## ADDENDUM NO. 1

CONSTRUCTION OF HOPKINS COUNTY SAFETY REST AREA

PROJECT NO. STP 2000(825) TE

ADDENDUM NO. 1 DATED March 30, 2016

Drawn by:  
Project No.  
STP2000(825)TE  
Date  
SEPTEMBER 16, 2015  
Sheet No.  
**AC-201**  
20 of 174 sheets

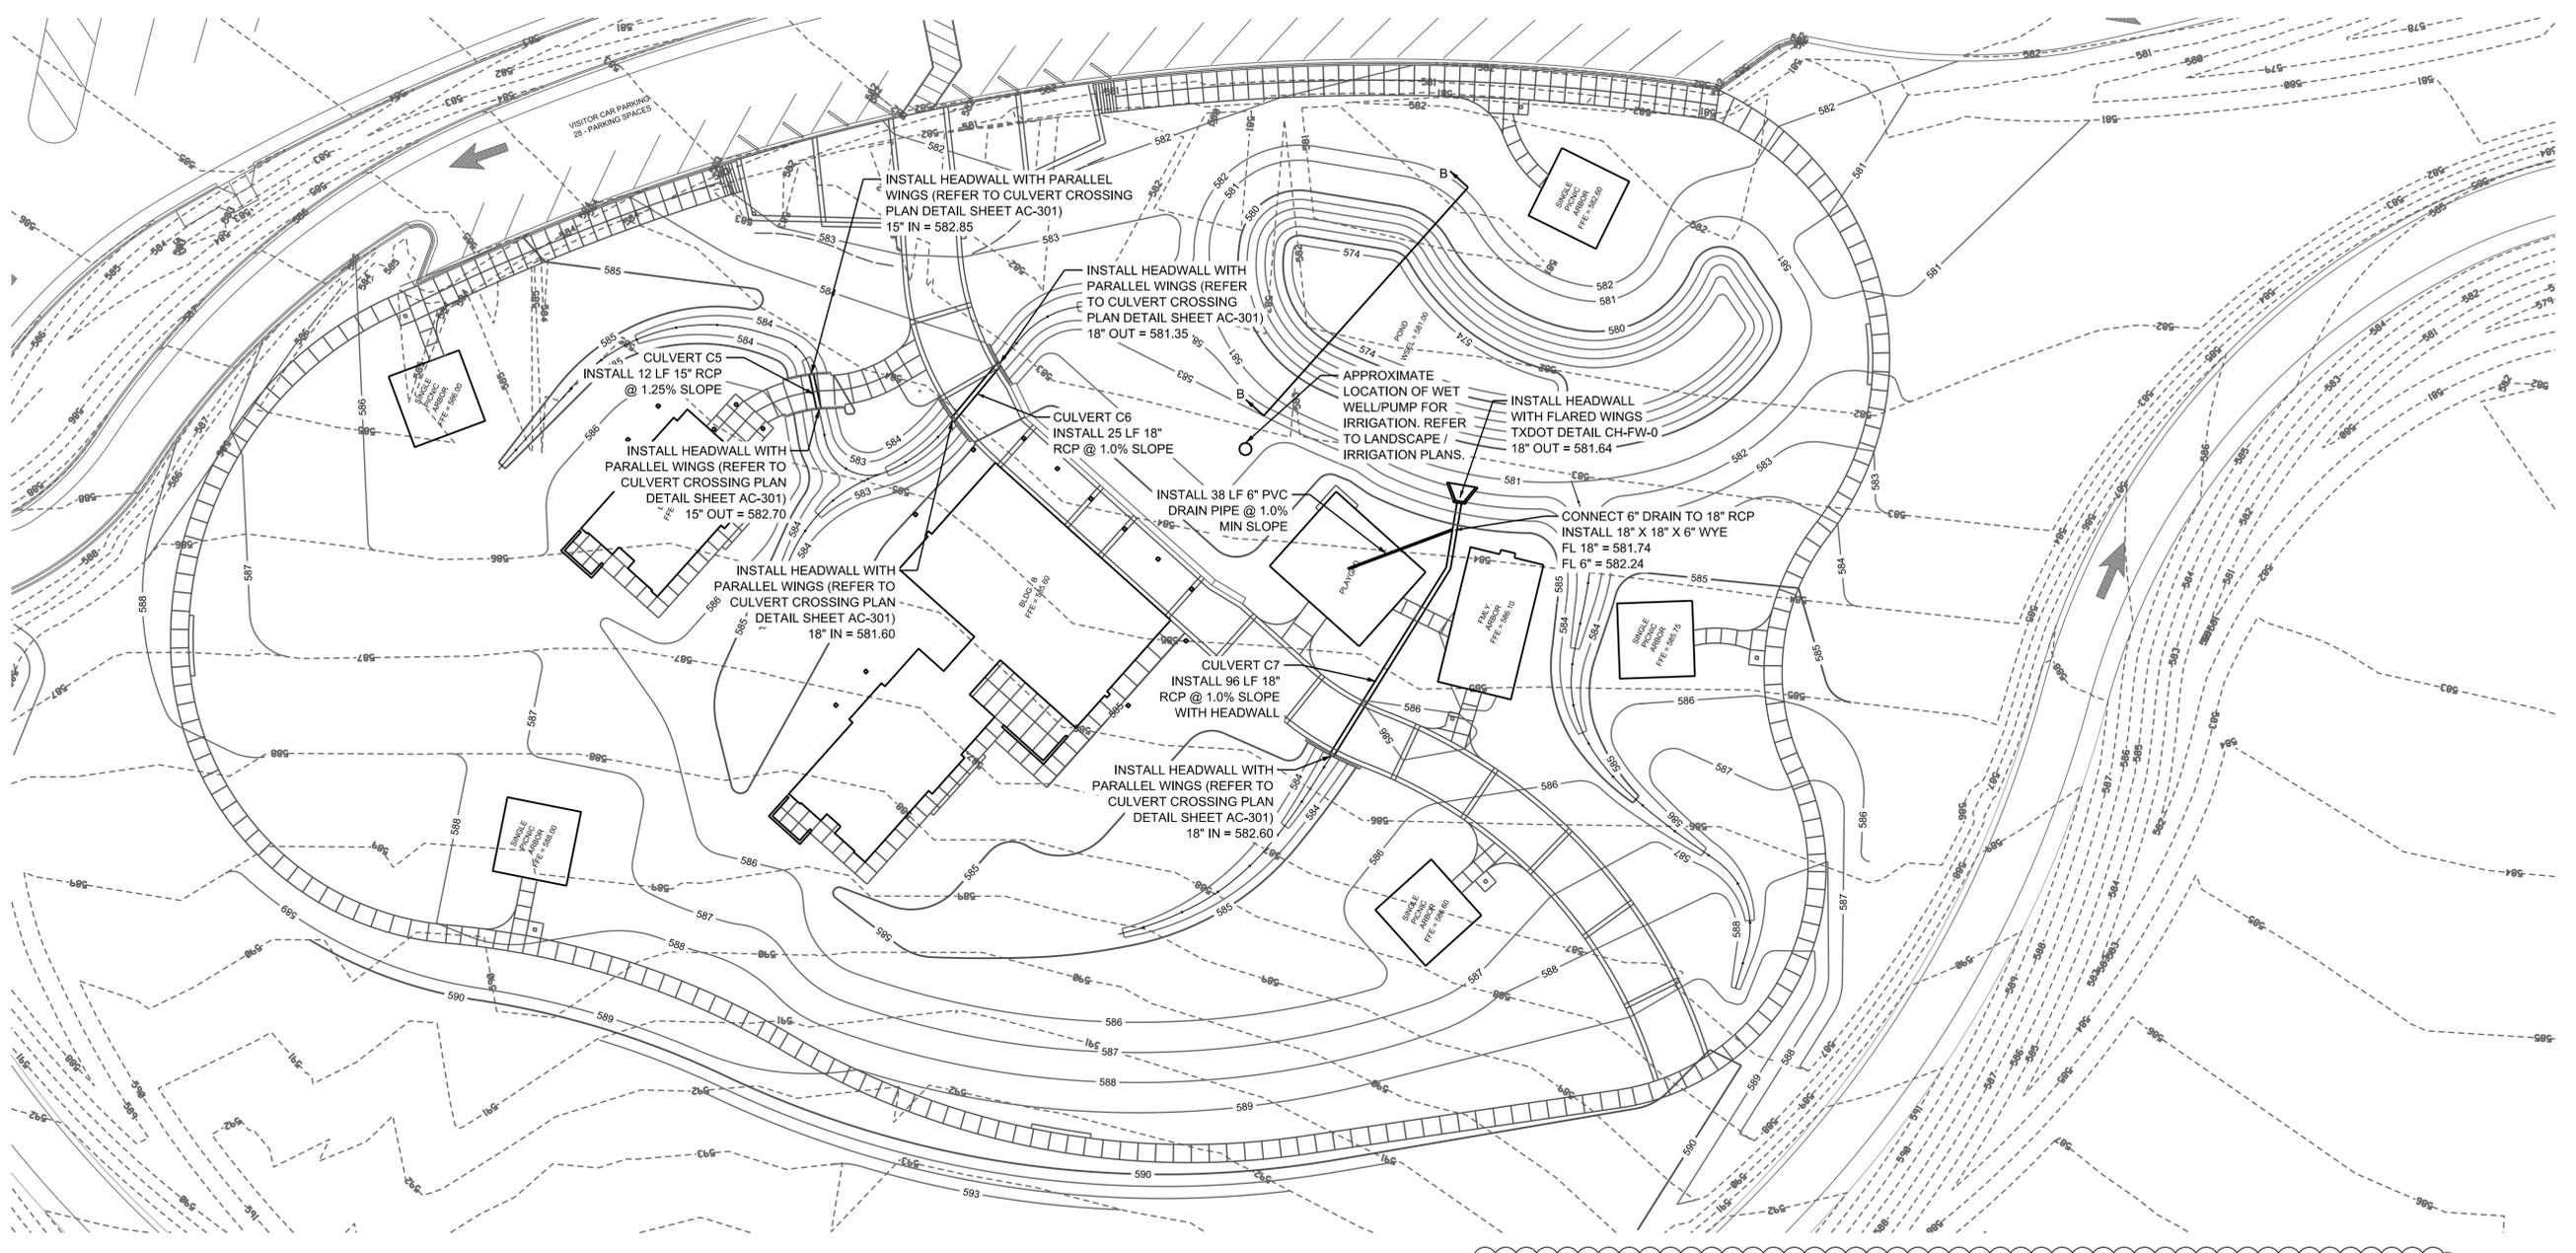
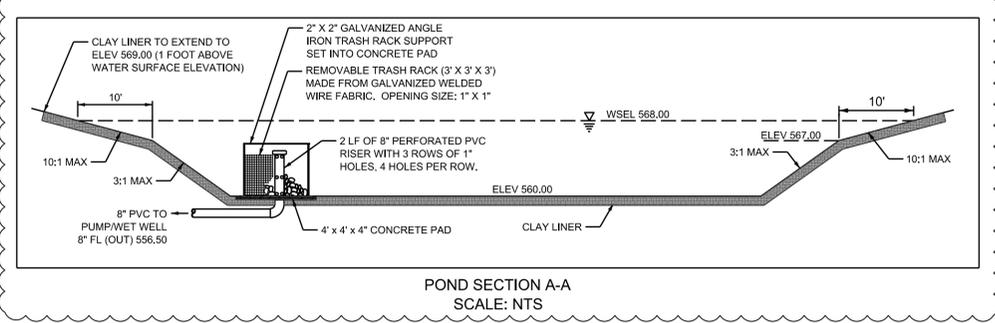
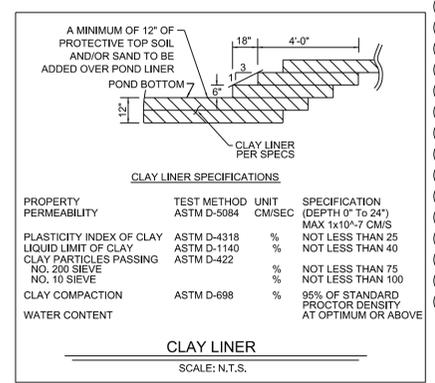
ITEM D2.3 Sheets AC-201 and AC-203: Replace with revised Sheets AC-201 and AC-203 attached to the end of the Addendum.

Revise pond section on both sheets to indicate an 8" pipe going from the pond to the pump / wet well as indicated on the Landscape drawings.

Add note to include "4' x 4' x 4" concrete pad" below removable trash rack. Clay line to go below slab.

16. There appears to be a discrepancy in the details for the connecting pipe from the pond to the wet well given on sheets AC201 and AC203 from the detail on sheet LI2.01 the pipe sizes on the AC sheet show a 12" pipe and the on the LI sheet show an 8" pipe. Could you please clarify this for us?

**1 ELECTRICAL SITE PLAN - EASTBOUND**  
 SCALE: 1" = 50'-0"

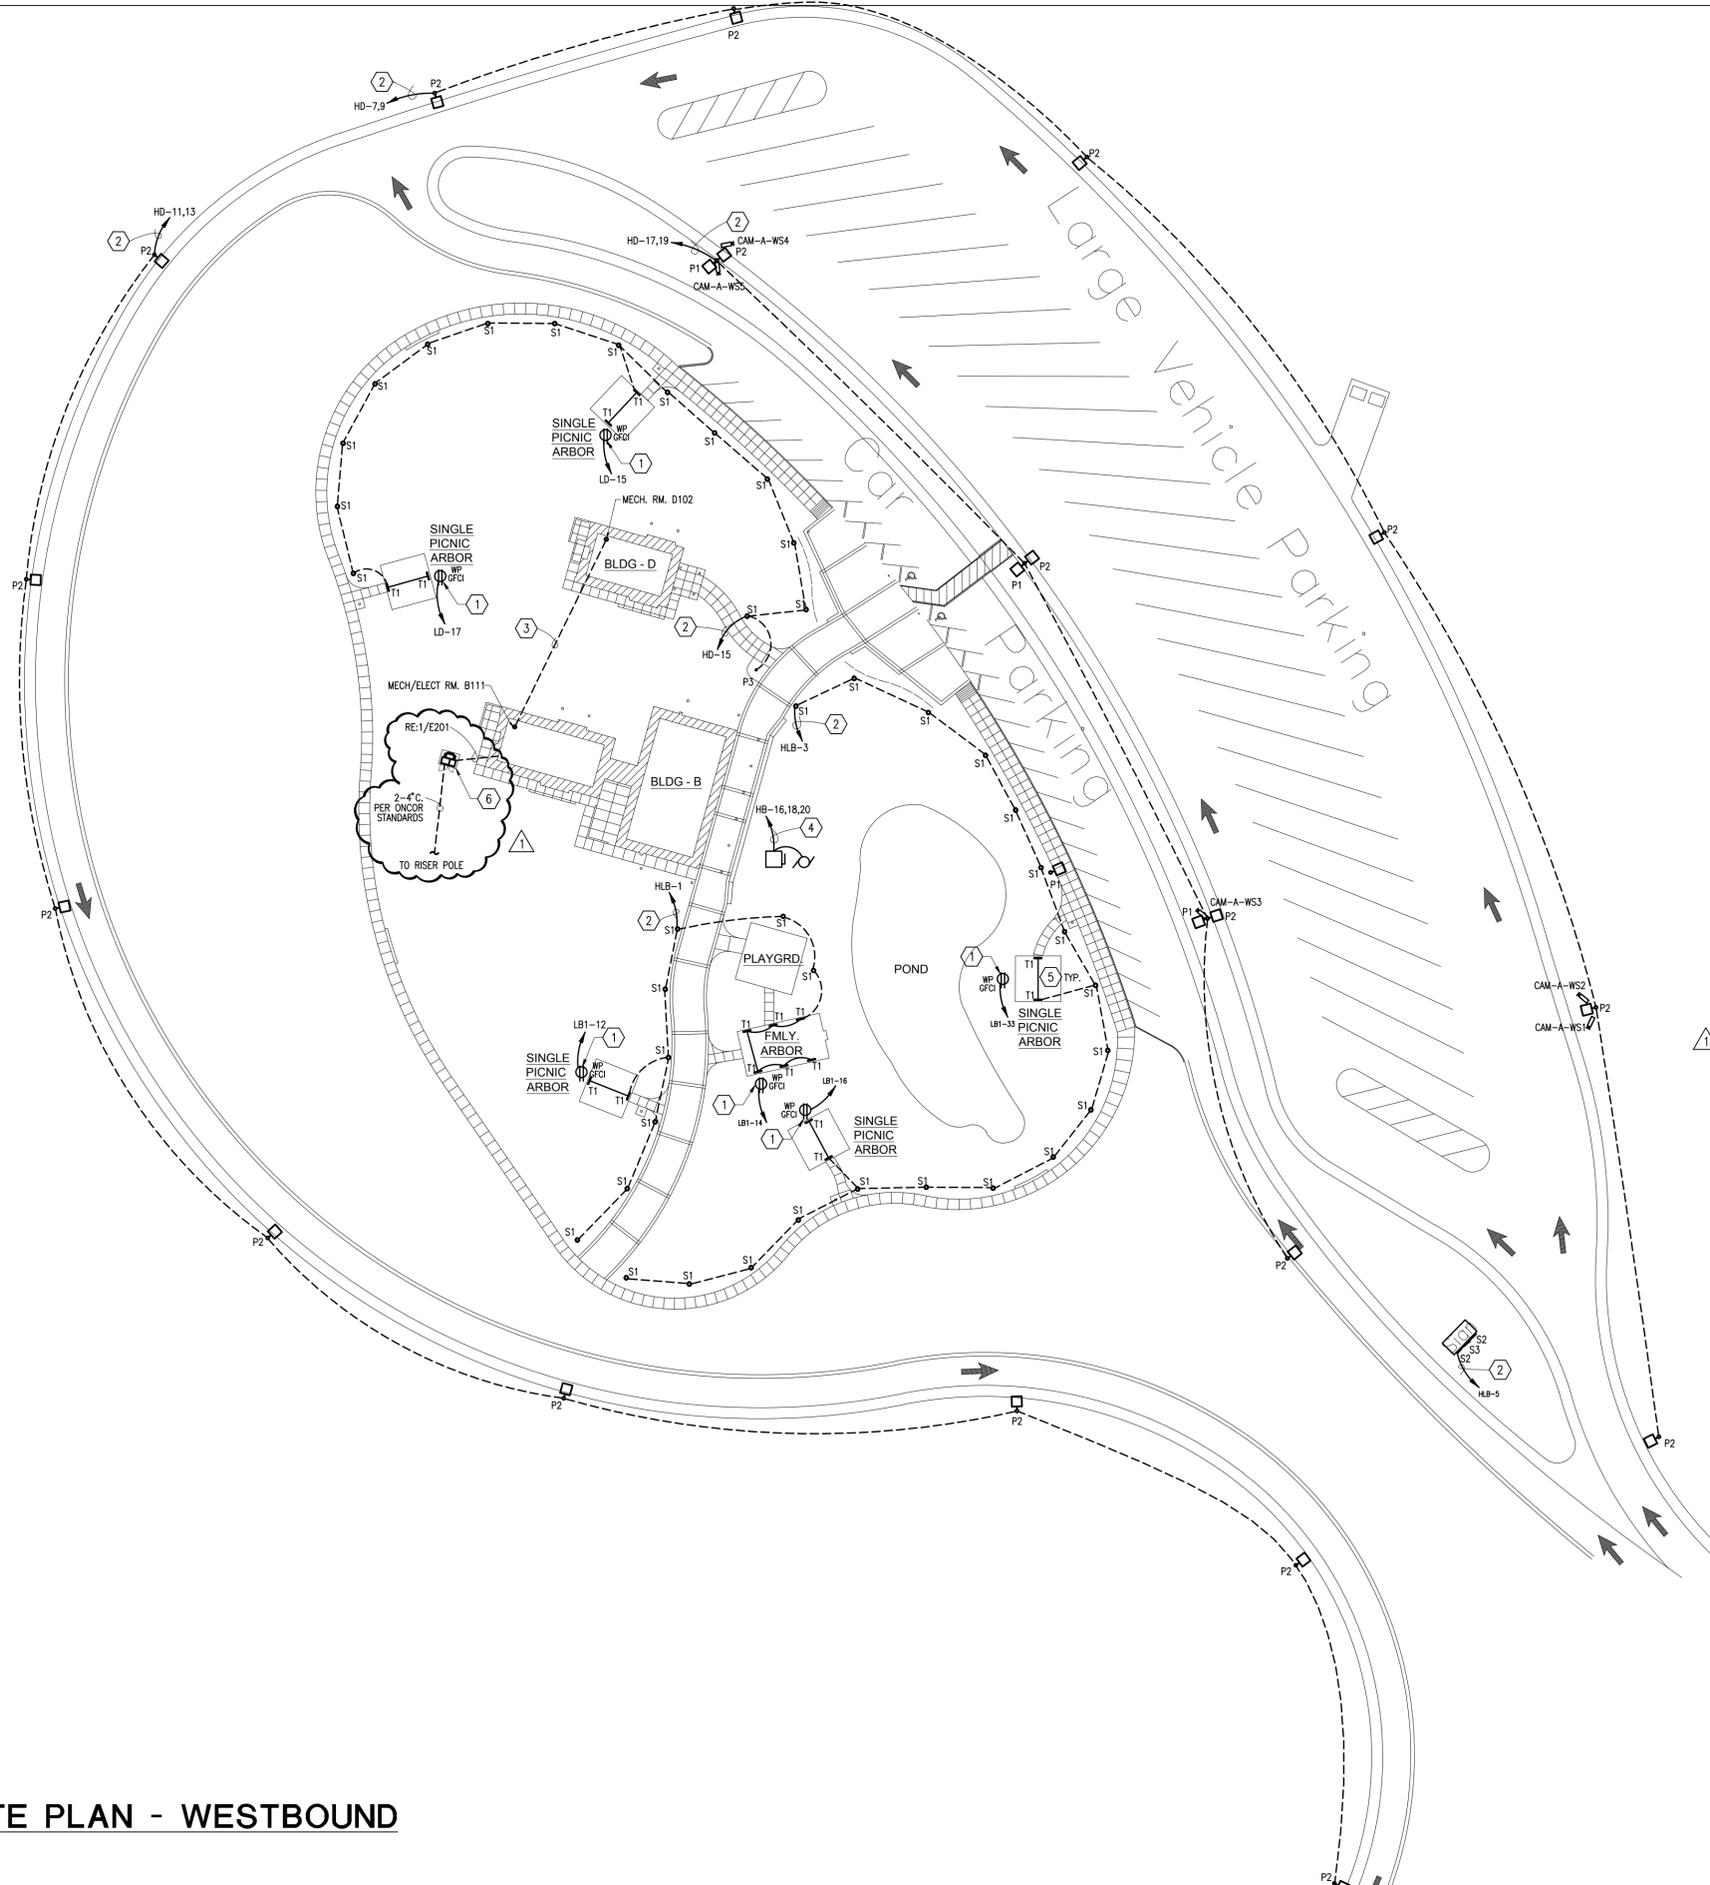
ITEM D2.4 Sheets E-100E and E-100W: Replace with revised E-100E and E-100W attached to the end of the addendum.

Add Keyed Note 6 as follows: "Provide concrete pad for transformer per Oncor utility standards."

⑥ PROVIDE CONCRETE PAD FOR TRANSFORMER PER ONCOR UTILITY STANDARDS.
